SIGAR 16-16 Inspection Report

Afghan Ministry of Defense Headquarters:
\$154.7 Million Building Appears Well
Built, but Has Several Construction Issues
that Should Be Assessed

Figure 2 - Headquarters Building Sections Schematic

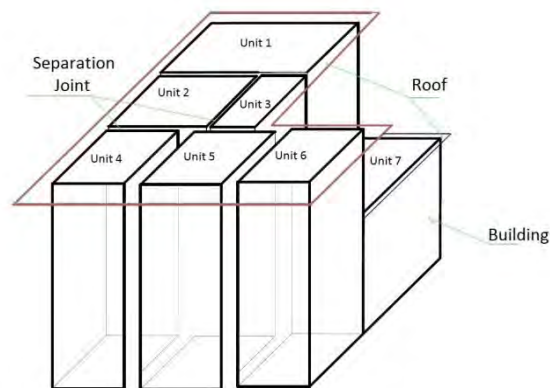
presents a schematic of the seven sections of the headquarters building and the separation joints that run from the foundation up to and through the roof. In addition to including separation joints to reduce damage to a structure during an earthquake, the building can include stronger walls, columns, and beams. Stronger walls called shear walls were included in this building. However, Building Unit 2 shear walls will not be strong enough to prevent the movement from exceeding the maximum allowable by the American Society of Civil Engineers standard 7.

- The separation joints were not constructed according to the structural design drawings. The structural design drawings were deficient because they identified 200 millimeters as the maximum width but did not provide more specific widths based on the seismic design calculations for each of the separation joints. However, the separations joints were constructed in compliance with the seismic design calculations and will handle movement caused by seismic activity. Building Unit 2 seismic design calculations of the building movement exceeds the maximum allowable movement according to American Society of Civil Engineers standard 7 Table 12.12.1, occupancy category IV, for a 5-story building.

- Not all of the separation joints were aligned vertically from the foundation up to and through the roof of the building, as the contract design documents required (see photos 1 and 2 showing that the separation joints are not continuous.) As a result, the seismic calculations used are not valid. Most significantly, a structural failure of the concrete frame could result in occupants being harmed and the affected areas being rendered unusable until repairs are made. We requested Quality Assurance/Quality Control reports and photographs from AFCEC for the period of the concrete pour and form removal of specific areas. However, we did not receive the reports or photographs for the separation joints that concerned us.

- 1. Assess the building's structural integrity where separation joints are not a continuous line from the bottom to the top of the building and the allowable building movement exceeds standards, and if needed, make deficient areas structurally sound.**
- 2. Assess the need for the installation of seismic lateral bracing on non-structural components suspended from the ceiling or floor above, such as heating/cooling equipment, duct work, dropped ceilings, electrical fixtures, and drain pipes.**

Photo 1 - Separation Joint Is Not Continuous: This Joint Ends at Top of the Third Floor, and Resumes at a Different Point on the Fourth Floor

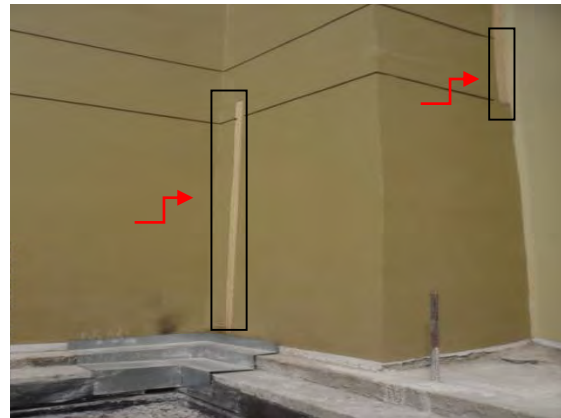
- Some separation joints that we were able to observe without destructive testing, which would require us to damage finishes on the inside of the building, were spanned with non-structural systems, such as drain pipes, dropped ceiling framing, and inflexible gypsum wall board (sheet rock), without flexible

Figure 3 - Typical Seismic Restraints for Suspended Equipment

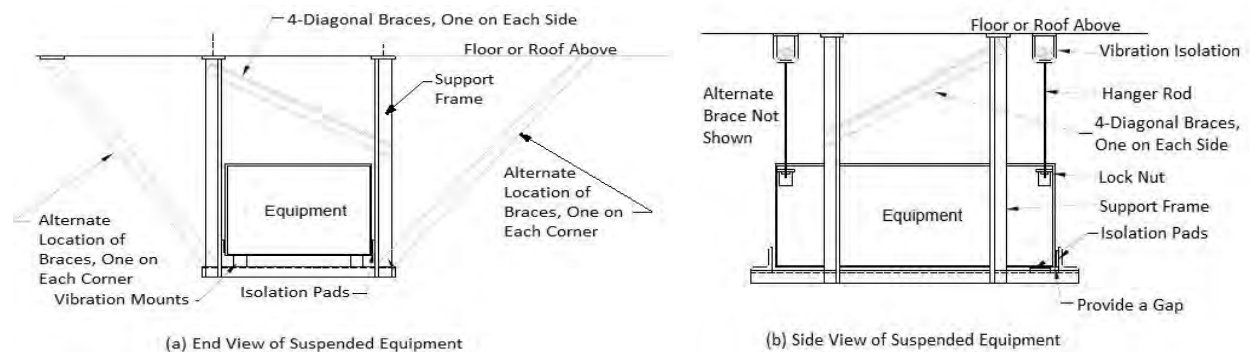
During our May 27, 2015, inspection, we found building equipment that did not have lateral bracing. Task orders 0030 and TG06 required that electrical and structural building standards, as defined in the Department of Defense's Unified Facilities Criteria, be followed in constructing the headquarters building.⁵ Based on the Unified Facilities Criteria, lateral bracing must be provided for items supported from the ceiling or floor above. Figure 3 shows typical seismic bracing, based on the Unified Facilities Criteria, used for equipment suspended from the ceiling or floor above.

As shown in figure 3, diagram (a) presents an end view of suspended equipment and shows lateral bracing both inside and outside of the support frame holding the equipment. Diagram (b) presents a side view of suspended equipment and shows the lateral bracing inside of the support frame, as well as the hanger rods tied into the ceiling or floor above and the suspended equipment.

According to the Unified Facilities Criteria and the American Society of Civil Engineers standard 7, all architectural, mechanical, and electrical components should be designed to include bracing, anchorage, isolation, and energy dissipation, as appropriate. This is because ceiling-mounted equipment, which includes heating/cooling equipment, mechanical duct work, and light fixtures, could swing freely during a seismic event and separate from their hangers and fall, damaging the equipment and possibly leading to injury.

3. **Install flexible connections across all separation joints of non-structural components, such as gypsum wall board, dropped ceilings, and drain pipes.**
4. **Assess the integrity of lateral bracing, anchorage, isolation, and energy dissipation of all equipment for compliance with the contract's seismic requirements, and make deficient items compliant with the requirements.**
5. **Assess the installed roof drainage system for compliance with the design documents and the International Building Code, and correct any deficiencies.**

Figure 4 - Example of Secondary Drain for a Roof with Parapet Walls

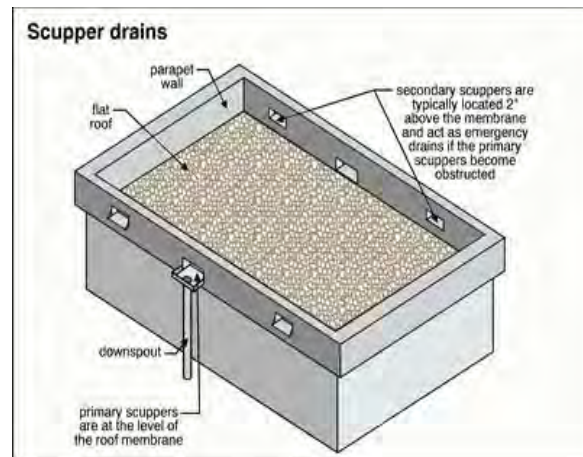
During our 2015 inspections, we found that the roof was not designed or constructed in accordance with the contract and code requirements for roof drainage.⁷ For example, we found that the installed roof drains measured 3 inches, not the 4 inches in diameter required by the ITSI engineers' revised calculations. In addition, secondary drains, known as scuppers, were not installed. The contract design documents required—as does the building code—a secondary emergency overflow for roofs with a parapet wall (see figure 4 showing examples of secondary emergency roof drains).⁸ Otherwise, if storm water is trapped on the roof behind the parapet walls, it could (1) damage the ventilation and heating/cooling equipment that is roof mounted on 4-inch high platforms, and (2) allow water to enter the roof access doors and flood the building causing damage to equipment and interior finishes.

Photo 4 - Handrail Is 31 Inches in Height and Is Dented

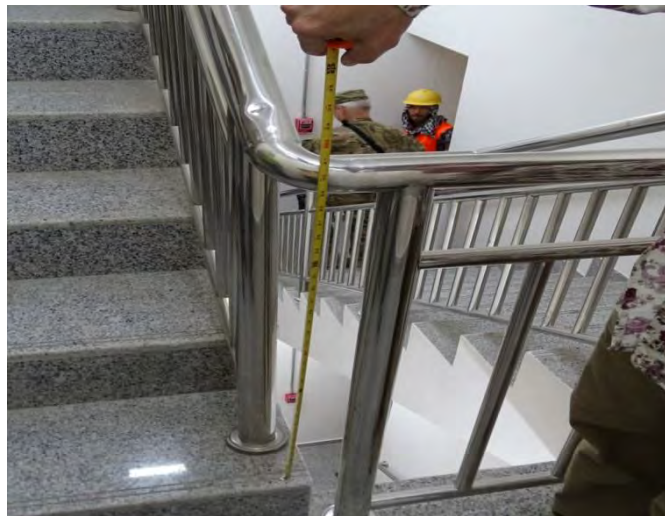
We found that the handrails on interior stairways were not installed at the proper height. During our May 27, 2015, site inspection, we measured the handrail height at 31 inches, which does not meet the minimum 34-inch height required by the International Building Code (see photo 4 showing the lower than required handrail height).¹² The 34-inch handrail height is standardized to allow the average person to reach for the handrail at an average height, so a lower height could contribute to falls on the stairways and injuries.

We also found that the handrail material was insufficient in quality. Our review of construction documents showed that the originally specified handrail material was mild steel pipe, but that AFCEC approved ITSI's request to substitute stainless steel thin-

walled pipe.¹³ The walls of the stainless steel pipe are no more than a fourth as thick as the originally required pipe. As a result, we found that the installed handrail has multiple dents, which is common for stainless steel thin-walled pipe. The substitution to the thin-walled stainless steel pipe will result in increased maintenance costs for the handrails, which run the risk of being dented further when furniture is moved into the building.

Our draft report, sent to Office of the Under Secretary of Defense for Policy, U.S. Central Command, U.S. Forces-Afghanistan, and CSTC-A for review on August 12, 2015, included a recommendation to make the necessary adjustments to the stairway handrails so they meet the International Building Code's height requirements. In commenting on our draft report, CSTC-A stated that Gilbane Federal initiated action to correct those handrails by November 2015. On January 7, 2016, during our follow-up inspection, we confirmed that CSTC-A acted on the recommendation and corrected the handrails. Therefore, we did not repeat the recommendation in our final report.
